Work Order ID 62187

Item Name: Floor Protector, Fwd LH (Black)

DRAWING NO. D3281	TITLE FLOOR PROTECTOR	REV. E	DART AEROSPACE LTD ENGINEERING ORDER		D.E.O. NO. D3281-E-1	SHEET NO. SHEET 1 OF 1	SCALE NTS
DRAWN 92	CHECKED K	MFG. APPR. SL	APPROVED H		DE APPR. H		
DATE 10.02.24	DATE 10.02.25	DATE 10/02/25	DATE 10.02.25		DATE 10.02.25

PURPOSE

D3281-1L08 FLOOR PROTECTOR (SHOWN)
D3281-2L08 FLOOR PRETECTOR (OPPOSITE)
 LOCATION OF ENGRAVING

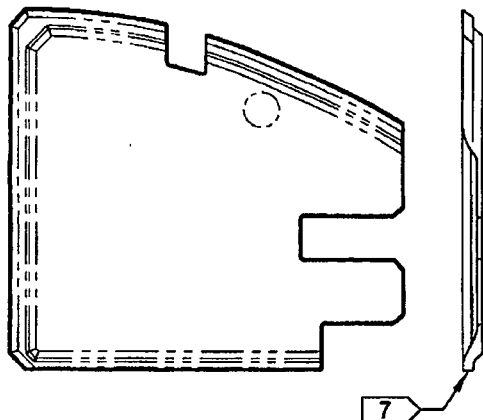
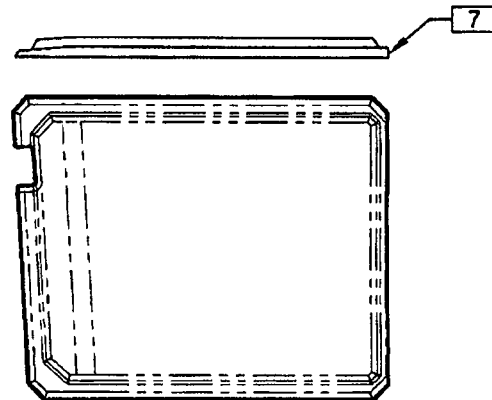
ADD "D3281-xL08" MATERIAL OPTION. EXISTING PARTS TO BE IDENTIFIED AS "D3281-xL02"

D3281-xL08 PARTS ARE EQUIVALENT TO THE RESPECTIVE "-x" PARTS EXCEPT AS DETAIL BELOW. THE MATERIAL, IDENTIFICATION, AND WEIGHT NOTES ARE AMENDED AS FOLLOWS:

- 2) MATERIAL: -xL02 = LEXAN F6006, BLACK No. 701, 0.093" THICK (MLEXS.093-F6006-02)
 -xL08 = LEXAN 90318 (PROTECT-A-GLAZE), 0.118 THICK, 112-CLEAR (MLEXS.118-90318-08)

- 7) IDENTIFICATION: IDENTIFY WITH DART P/N "D3281-xLxx" AND B/N "Bxxxxx" ON SMOOTH SIDE OF PART USING VIBRATING STYLUS.
 FOR -xL08 PARTS, LOCATE ENGRAVING ALONG PERIMETER OF PART AS SHOWN.

- 8) WEIGHT: D3281-1L02/-2L02 = 0.95 lb D3281-1L08/-2L08 = 1.13 lb
 D3281-1L02/-2L02 = 0.87 lb D3281-3L08/-4L08 = 1.05 lb
